CITY OF NOVI CITY COUNCIL JULY 27, 2026

SUBJECT: Consideration of final approval of the request for JSP25-02 Camelot Parc Townhomes, for a Planned Suburban Low-Rise (PSLR) Overlay Development Agreement Application and Concept Plan.

AVALON PARK DEVELOPMENT, LLC
CAMELOT PARC TOWNHOMES
PSLR OVERLAY CONCEPT PLAN
COVER SHEET

MAVALON PARK DEVELOPMENT, LLC
CAMELOT PARC TOWNHOMES
PSLR OVERLAY CONCEPT PLAN
PRESERVATION AREA PLAN &
HABITAT ENHANCEMENTS

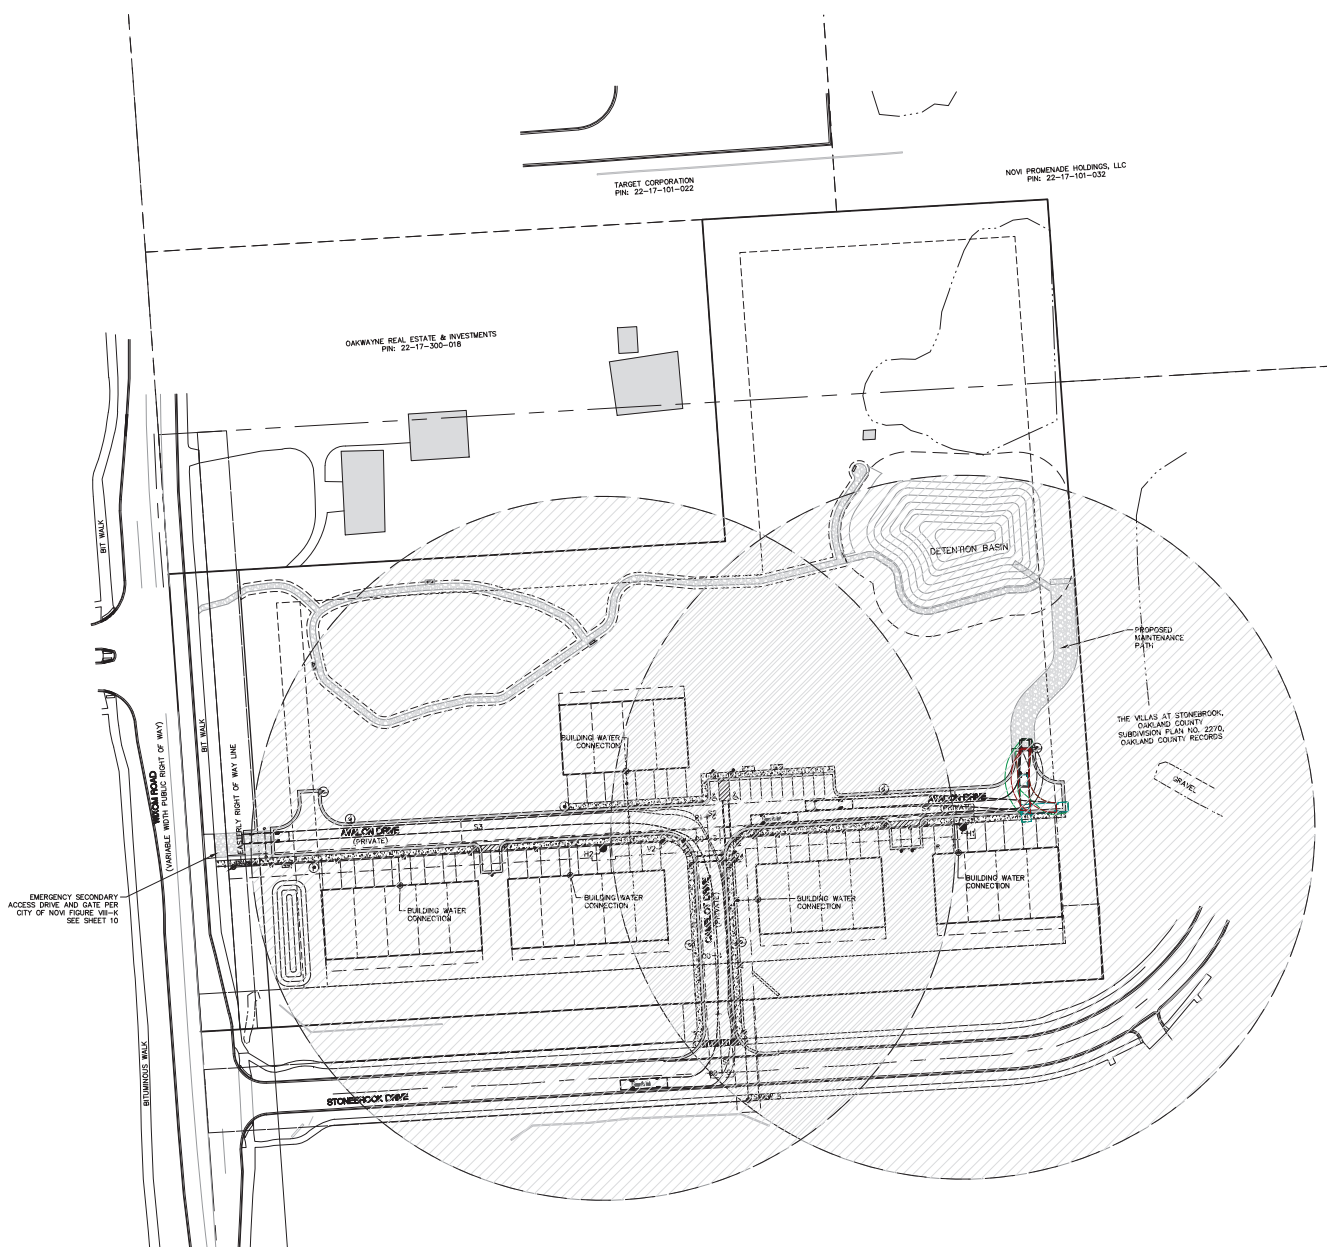
10. **Preservation of Natural Features:** Sheet 8 of the revised PSLR plan shows the area to be protected by preservation or conservation easements is 4.25 acres. Within this area the applicant indicates they will remove invasive species, sow native seeds to promote growth of desirable species, and place new habitat structures for wildlife.

VILLAS AT STONEBROOK PAVEMENT
MAINTENANCE CONTRIBUTION CALCULATION

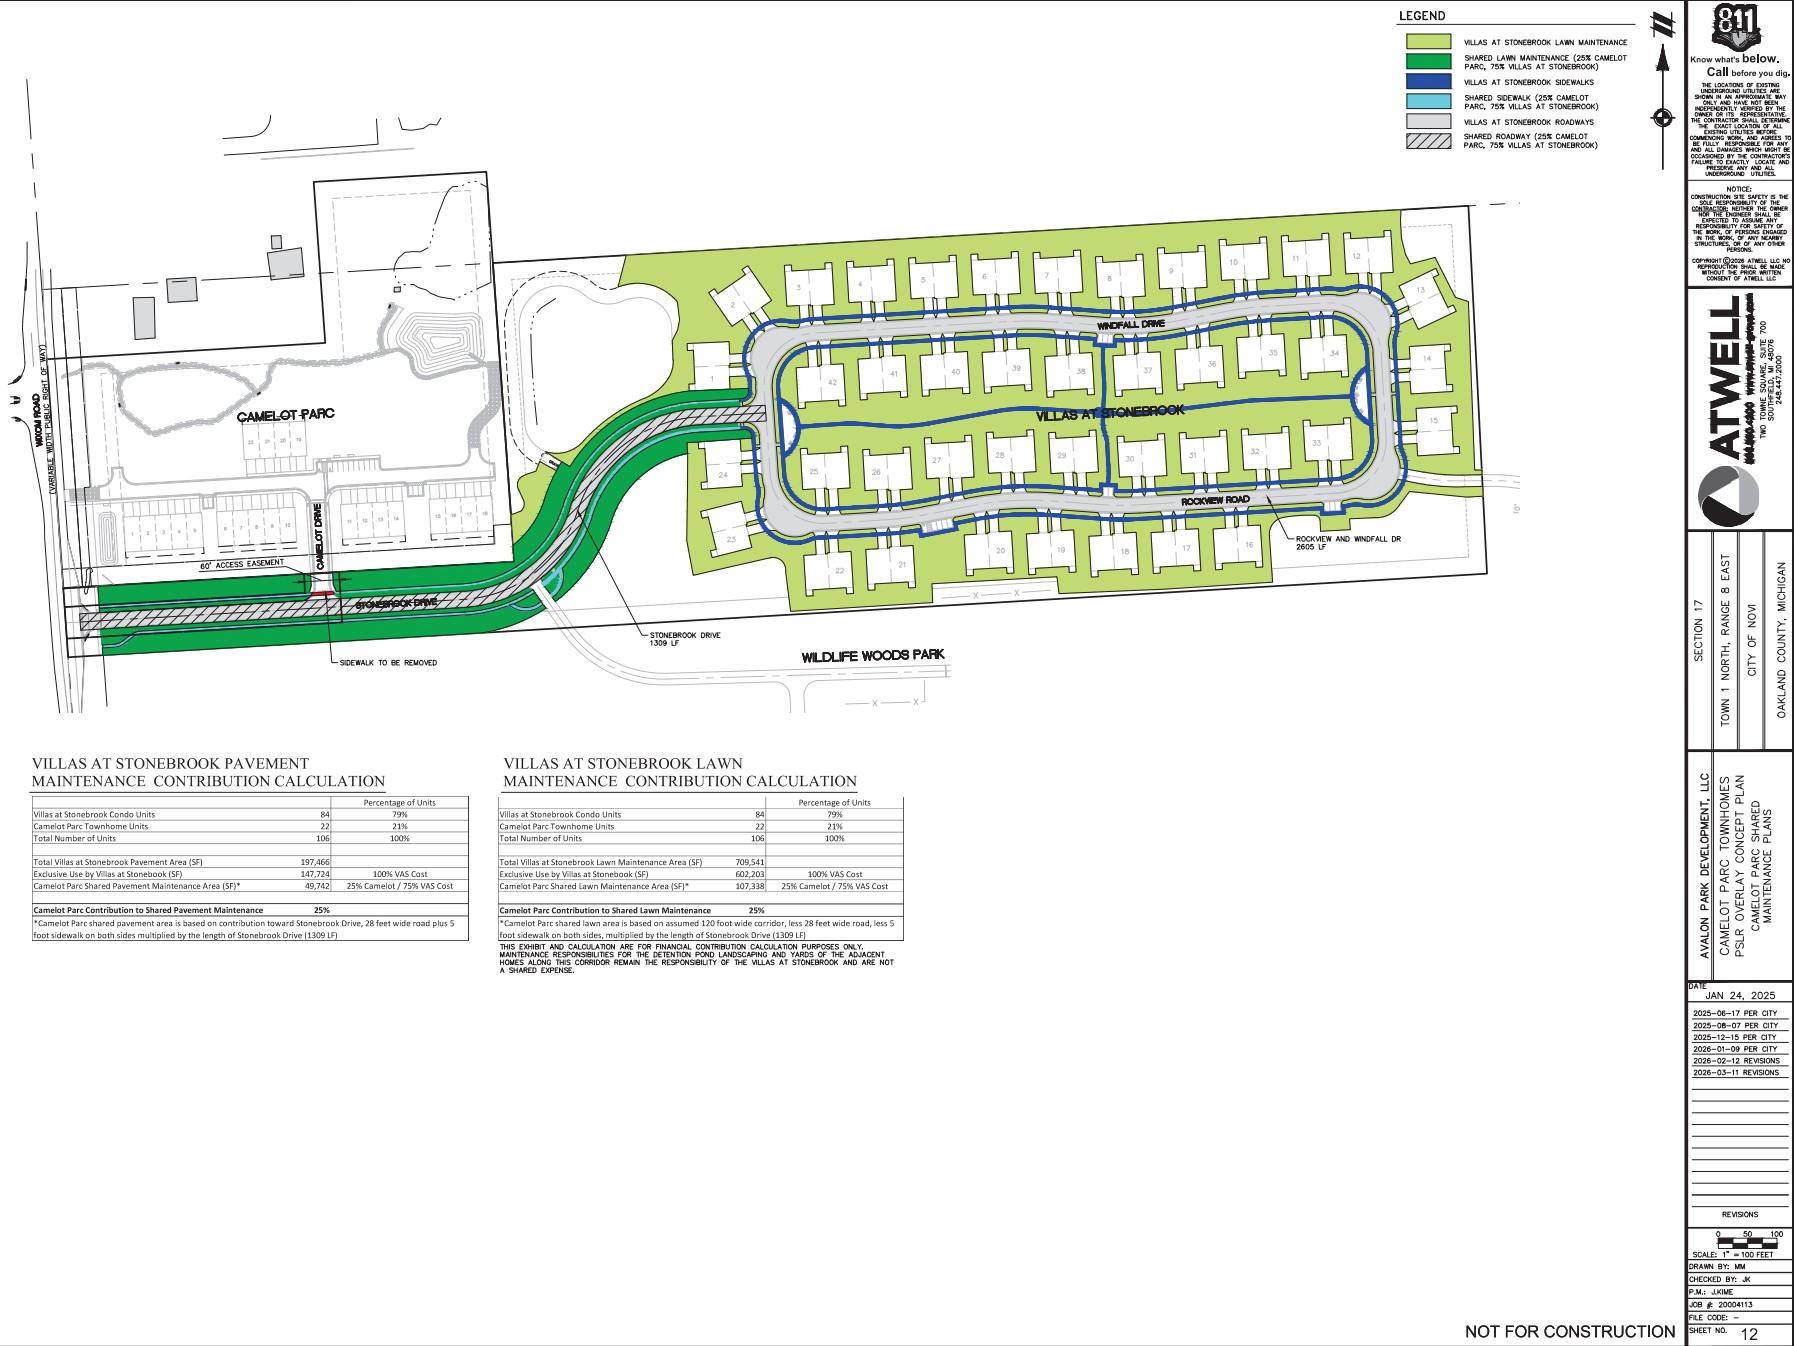
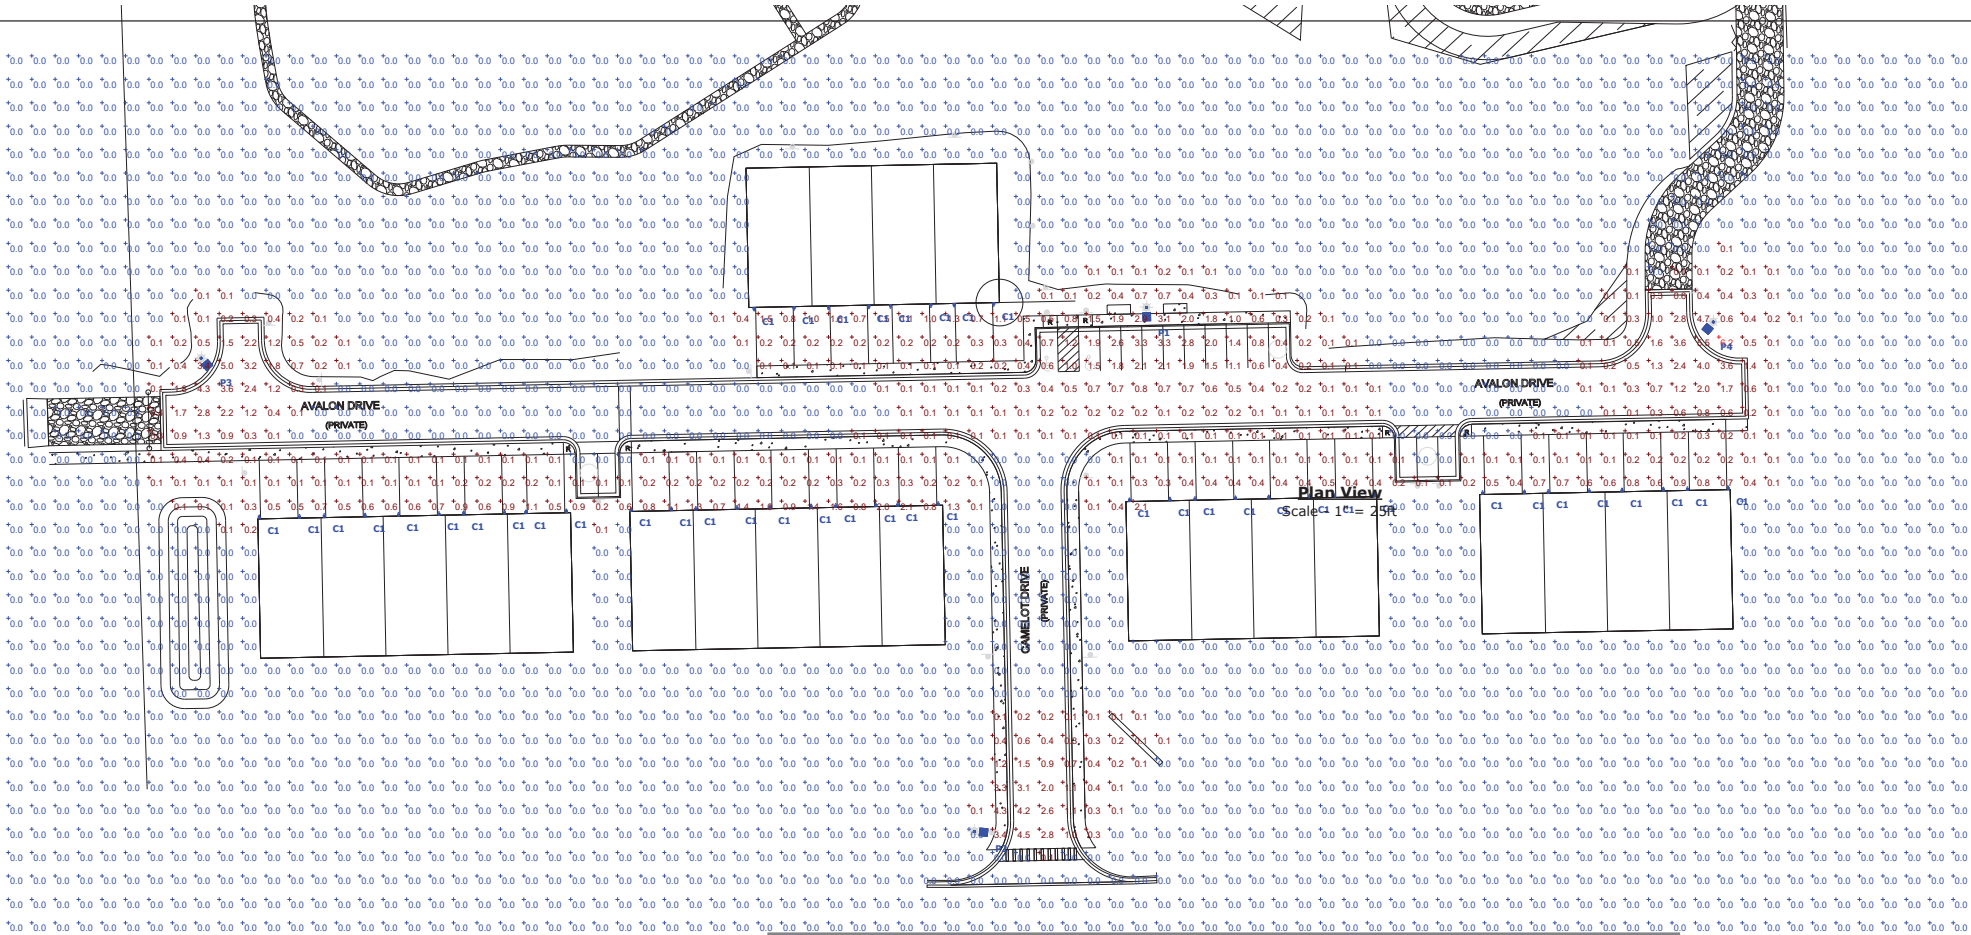
6. **Stonebrook Drive:** The applicant has included a proposed Road Maintenance Plan on Sheet 12 for Stonebrook Drive. The plan calculates a contribution for the proposed Camelot Parc toward Stonebrook Drive maintenance costs based on the length of the road, percentage of road used to access Wildlife Woods Park, and the total number of units for each development. **As Stonebrook Drive is a private road owned by Villas at Stonebrook HOA, the applicant has indicated they are discussing the road maintenance agreement with them. Any cost-sharing agreement would be a private agreement between the two entities.**

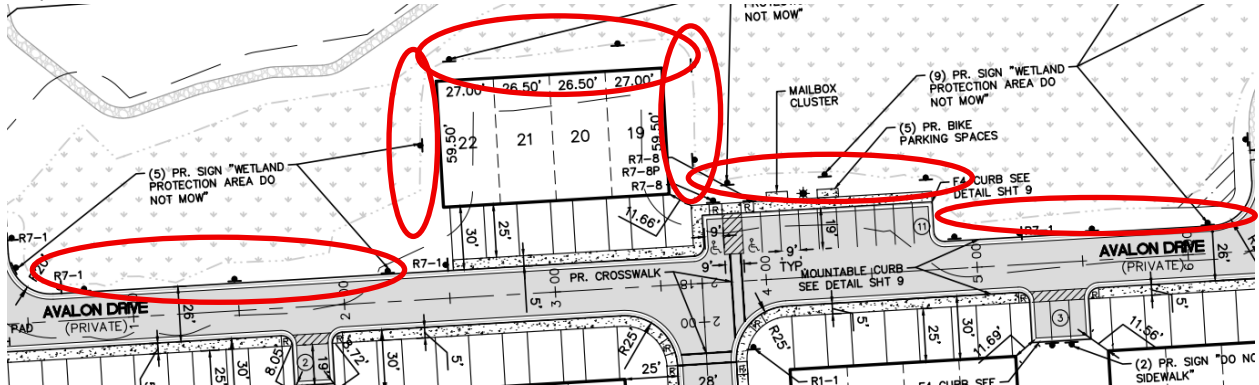
Impact	Amount
Forested Buffer	8,198 sq. ft. (0.19 acre)
Emergent Buffer	20,408 sq. ft. (0.47 acre)
Scrub-shrub Buffer	2,652 sq. ft. (0.06 acre)
Total Buffer Impact	31,258 sq. ft. (0.72 acre)

Requested edit: In future submittals, buffer impacts should be differentiated by permanent and temporary impacts (if applicable). If impacts are temporary, descriptions or sequencing should be provided showing how the temporary impacts will be restored. The temporary wetland restoration sequencing provided on Sheet 7 can be applied to any temporary buffer impacts – the header will need to be updated. Identify any temporary buffer impacts using a different symbology in the site plan.

Requested Placement locations

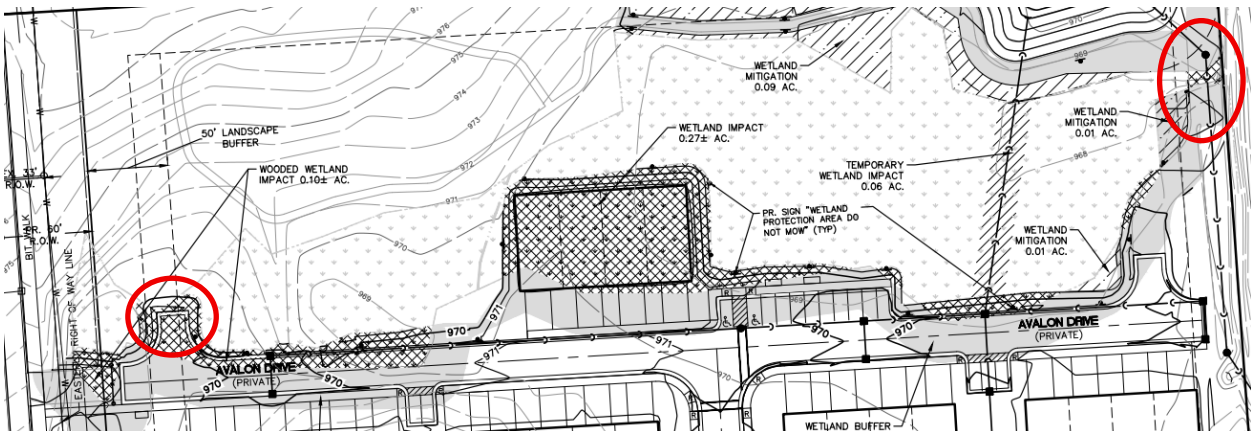
The italicized text and image below are originally from Comment 5 in the July 2025 wetland review and has been addressed in the rrPSLR submittal on Page L-1.

Due to the extensive proposed loss of wetland buffer along the southern remaining wetland area, it is requested that the applicant perform environmental enhancement along the southern portion of the remaining wetland (see screenshot below). The applicant should plant at least three different species of wetland rated shrubs throughout the southern boundary of the wetland. This will allow a small separation from the wetland and the proposed development. Additionally, it will deter any accidental mowing of the wetlands and remaining buffer areas. Shrubs could include three of the following species:
